Origination Form
Proposed Revisions to a Standard Plans Index

Originator:	Turley, Joshua	Index Number:	700-091
Date:	4/23/2025	Sheet Number(s):	Sheet 2
E-mail:	Joshua.Turley@dot.state.fl.us	Index Title:	CATWALK DETAILS

CATWALK DETAILS

INDEX SHEET
 700-091 2 of 3

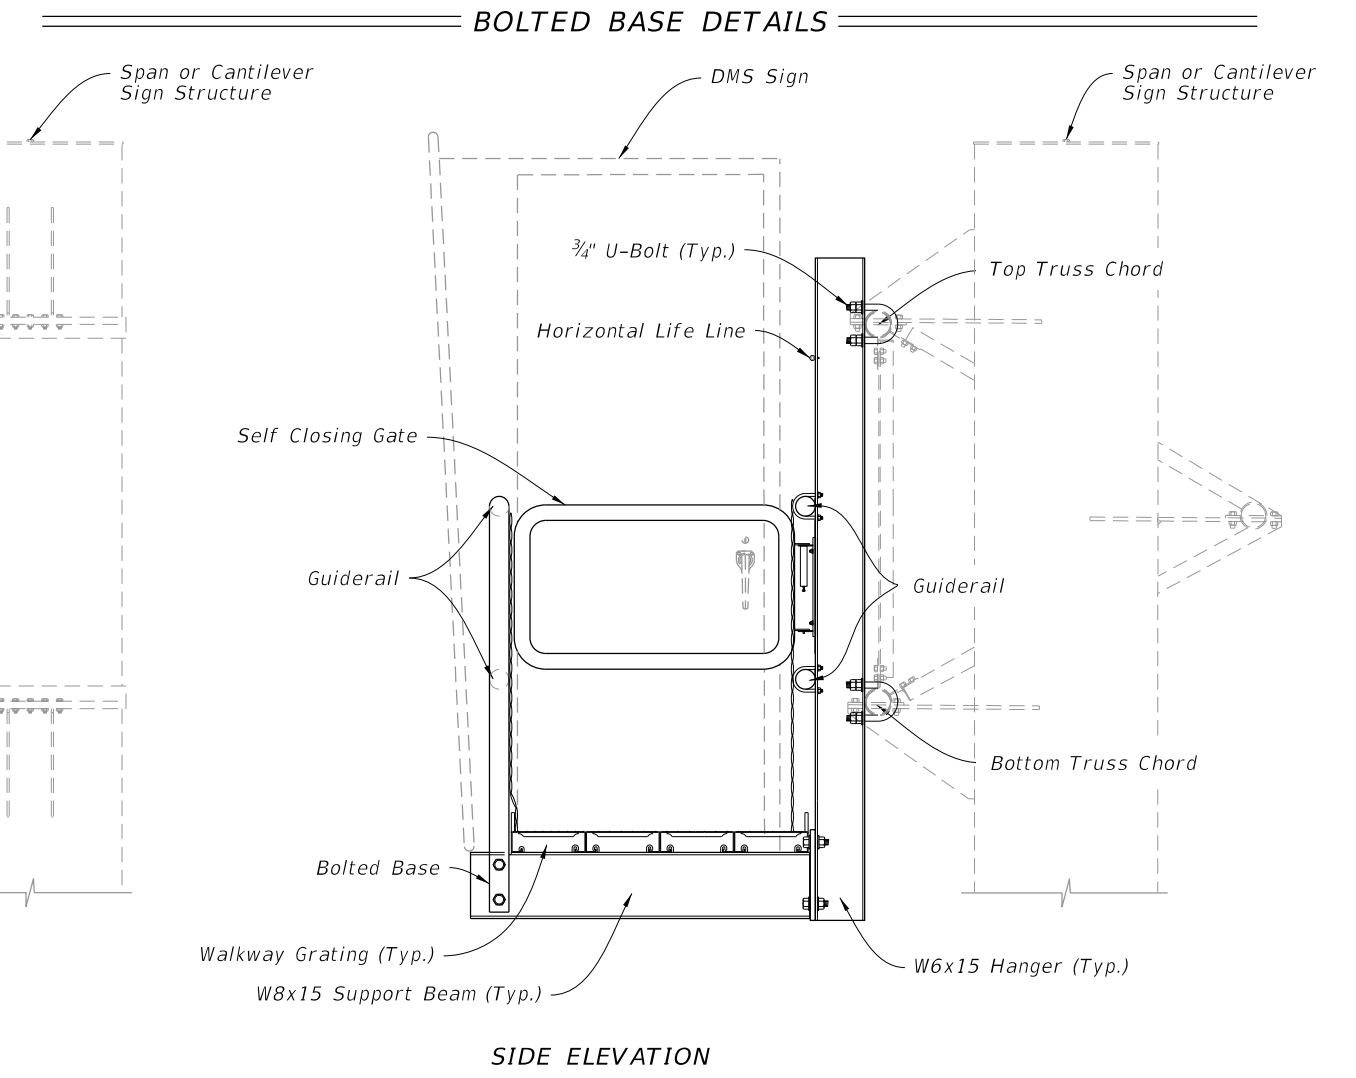
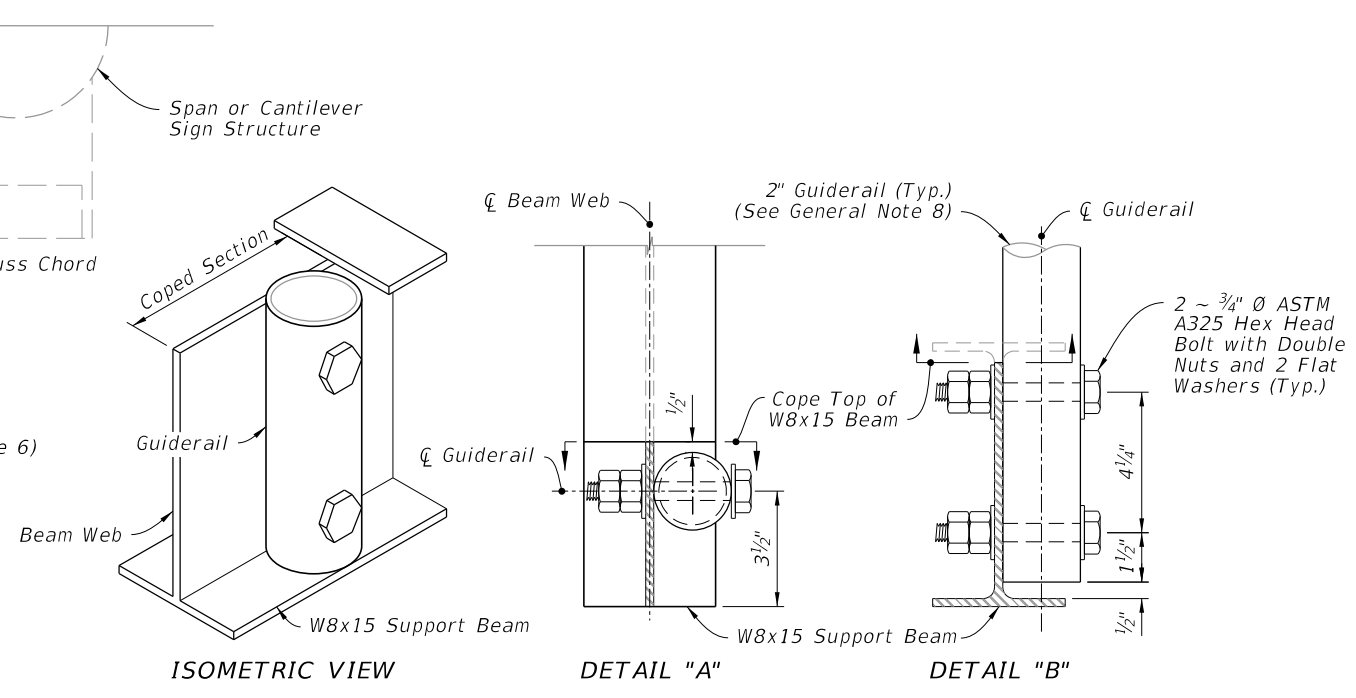
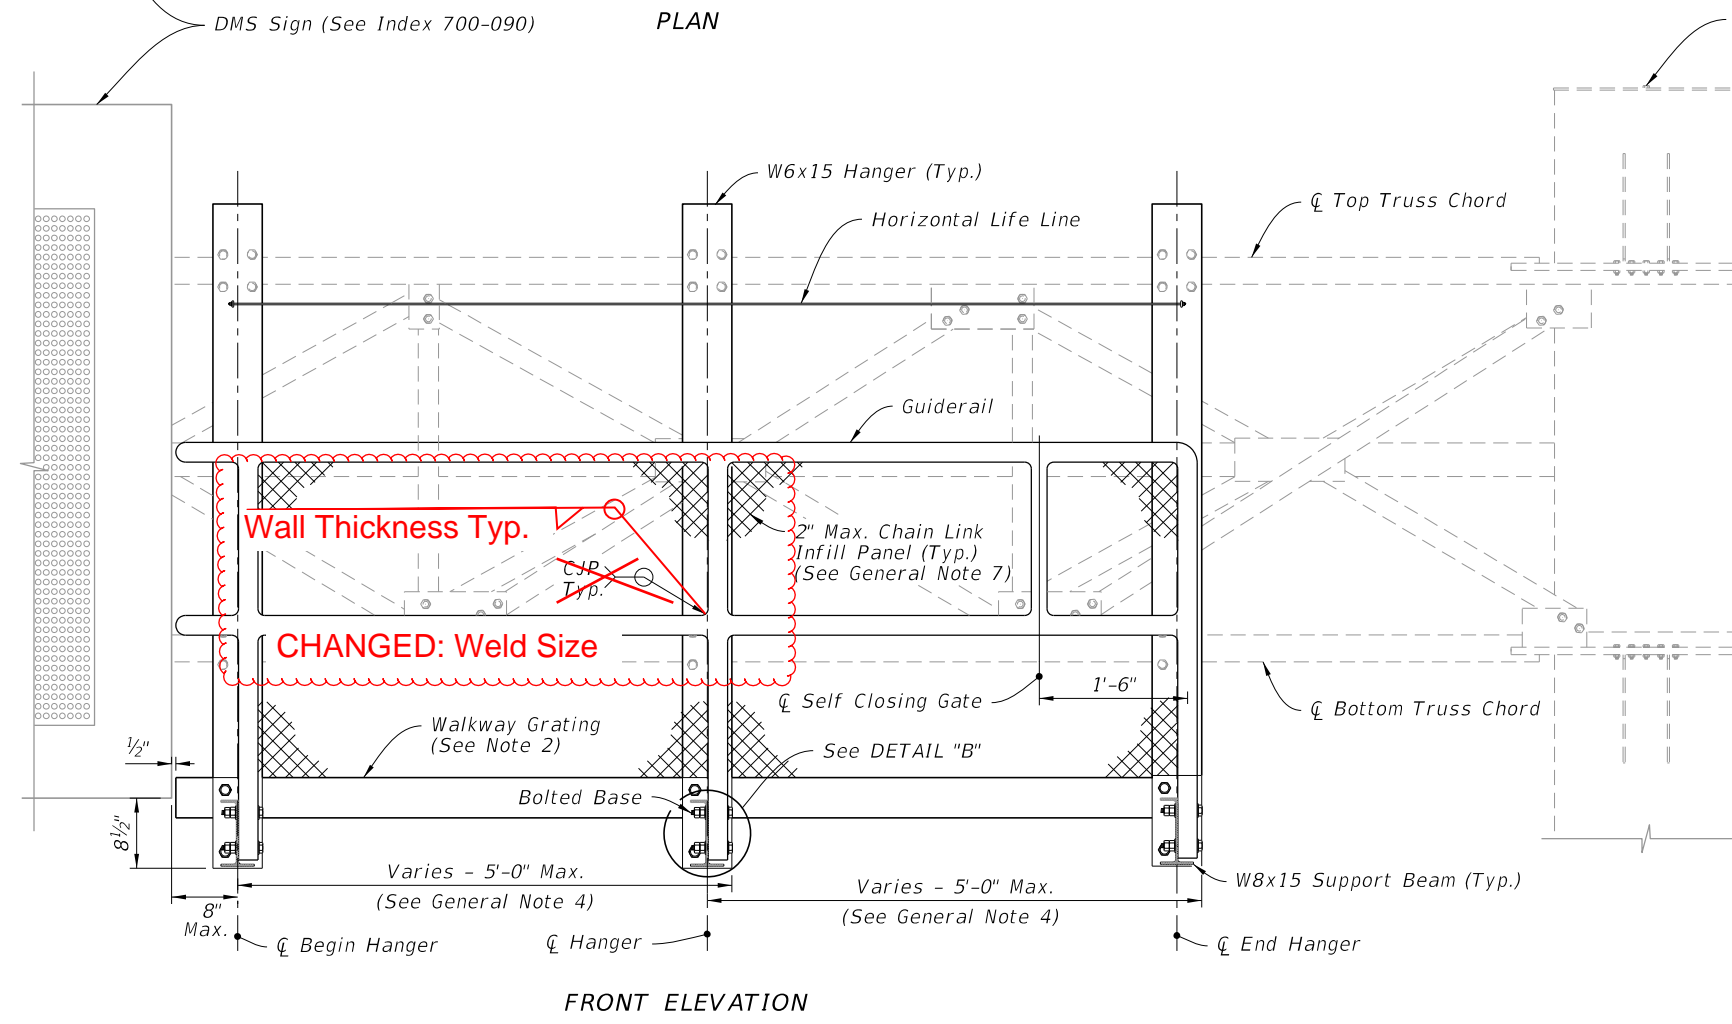
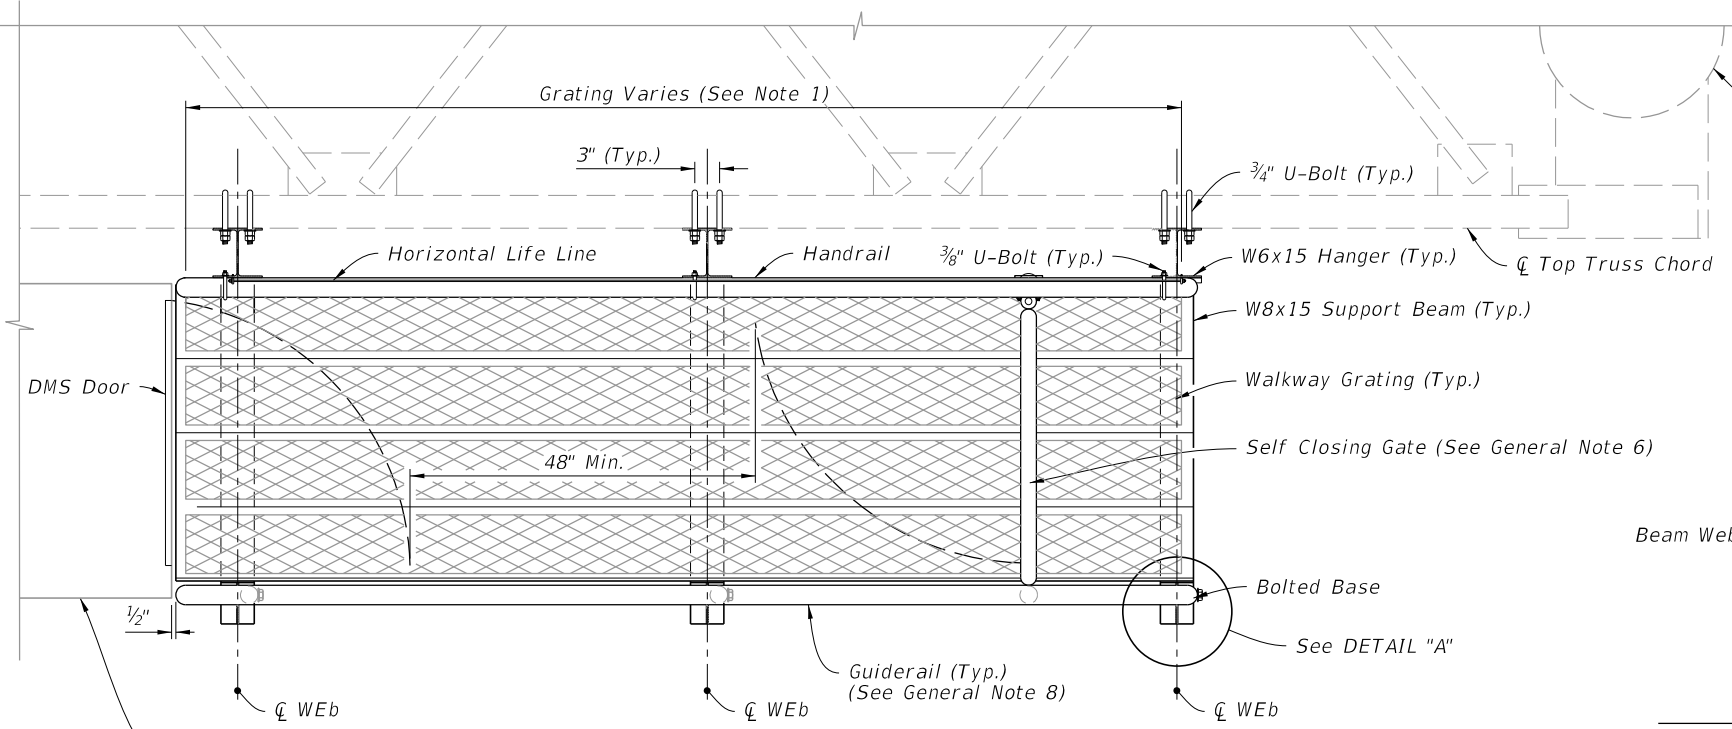
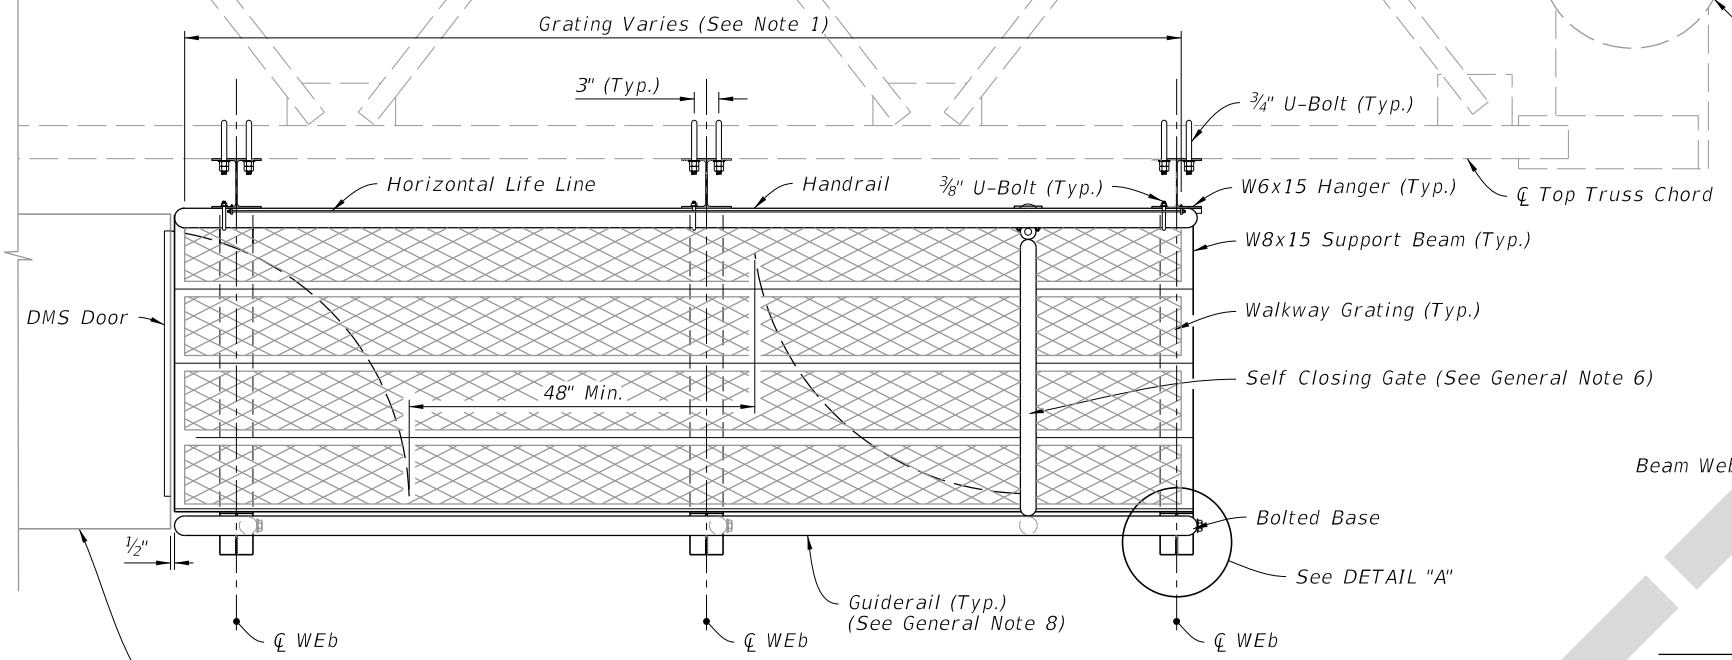
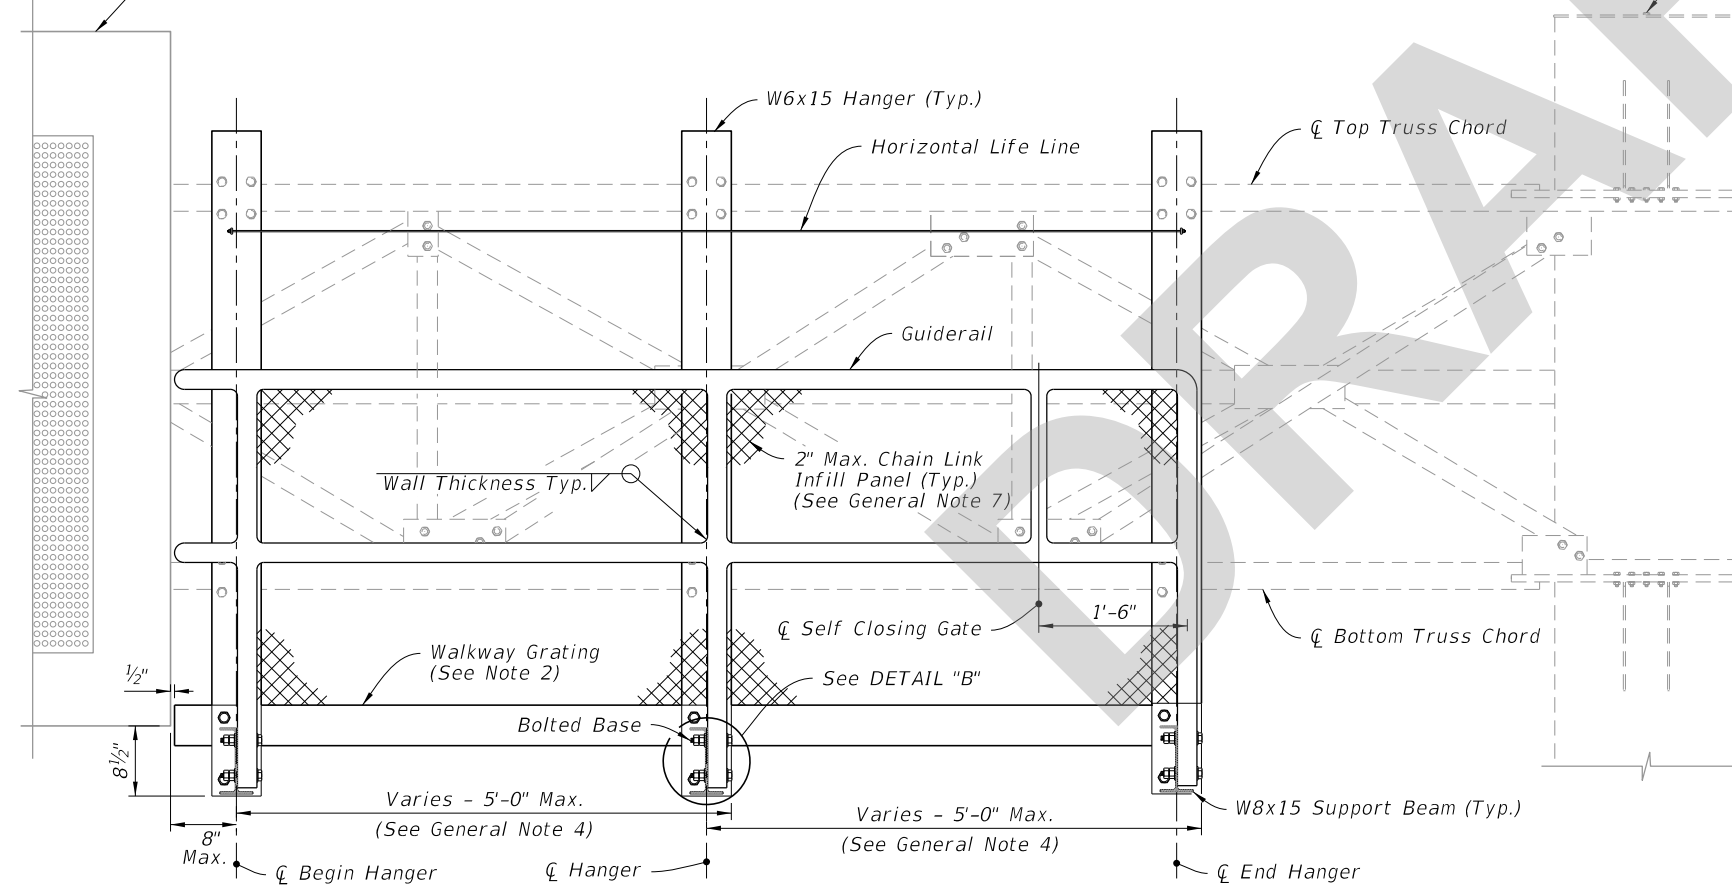
Sheet 2: Changed the weld size for the tube to tube connections of the guardrail.

The original weld size was overly conservative and not cost-effective. After analysis, the Structures Office specified a more appropriate weld for this index.
